RE: Section 106 Consultation and Review on-
*Re: AC130J Formal Training Unit Relocation at Kirtland Air Force Base
Environmental Assessment
Kirtland Air Force Base
Albuquerque, Bernalillo County, New Mexico*

Kirtland Air Force Base (AFB) acknowledges receipt of the Pueblo of Isleta's November 9 and December 20, 2022 letters regarding the proposed AC-130J Formal Training Unit (FTU) Relocation at Kirtland AFB. We appreciate the thoughtful response and the opportunity to engage in continued consultation with the Pueblo of Isleta. This will provide an excellent opportunity to strengthen our relationship, as we strive to be good neighbors now and in the future.

**Environmental Assessment for
Addressing the Air Force Special
Operations Command AC-130J
Formal Training Unit Relocation
at Kirtland AFB, New Mexico**

Proposed Isleta Drop Zone Route

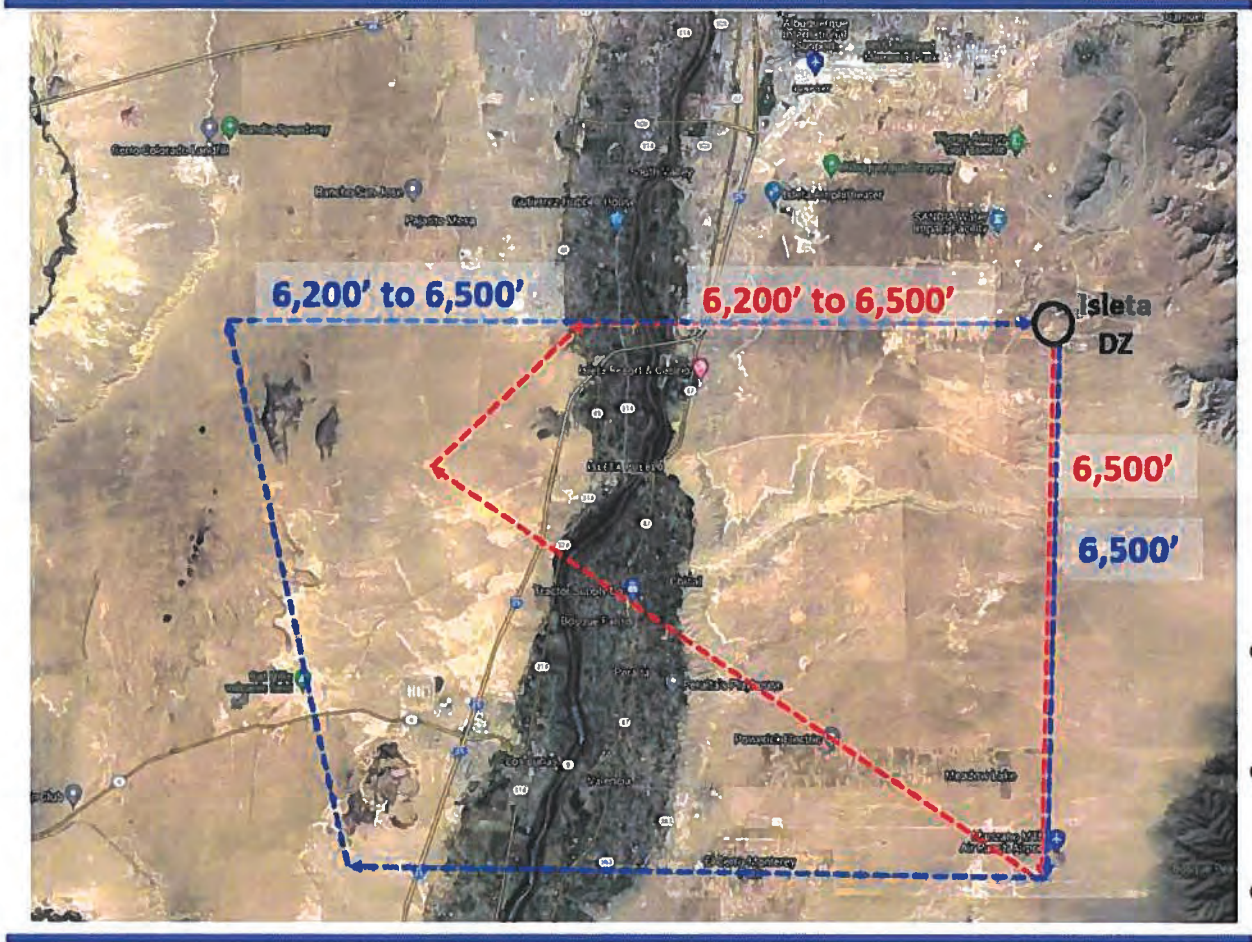
As part of our recent discussions with Pueblo representatives on December 22, 2022, I committed to reviewing our flying operations near the Pueblo of Isleta. Following our meeting I asked my team to analyze our current operations and examine options to decrease overflights of Isleta Pueblo, particularly at night. Most flights near the Pueblo are related to drop zone operations at Isleta Drop Zone and the flight path crews take to conduct multiple airdrops in minimum time during a training sortie.

For background, the Isleta Drop Zone is one of only two local drop zones available to the 58th Special Operations Wing to conduct critical airdrop training for our MC-130J and HC-130J crews. While both drop zones are usable during the day, only Isleta Drop Zone is usable for night operations due to terrain and regulatory limitations on the other drop zone. Operations currently account for a no-fly area around the village preventing overflight below 1500 feet. Flights at that altitude will still be seen and heard from the ground and I acknowledge the concerns the Pueblo has raised in this regard.

To help address those concerns, my team has developed an alternate flight path that extends our flight legs further south and west, avoiding flights over the village to the maximum extent possible. While this flight path increases the time between successive drops, and thus decreases the number of training drops crews can conduct within a given time period, I believe the change will limit disruptions to the Pueblo residents, particularly at night.

I would like to implement the new routing, detailed in the attached graphic, for a trial period of two weeks beginning February 1, 2023 for all operations conducted at Isleta Drop Zone from sunset to sunrise. During that period I request feedback on whether the changes are having the desired effect of reducing disturbances to Pueblo residents, with the intent to codify the new routing in local regulations and make it an enduring change. My point of contact for feedback is

Red – Current Isleta DZ routing
1,000-1,500 ft* above the ground

Blue – New Isleta DZ routing
starting on 1 Feb 2023
1,000-1,500 ft* above the ground
* 1,500' above populated areas
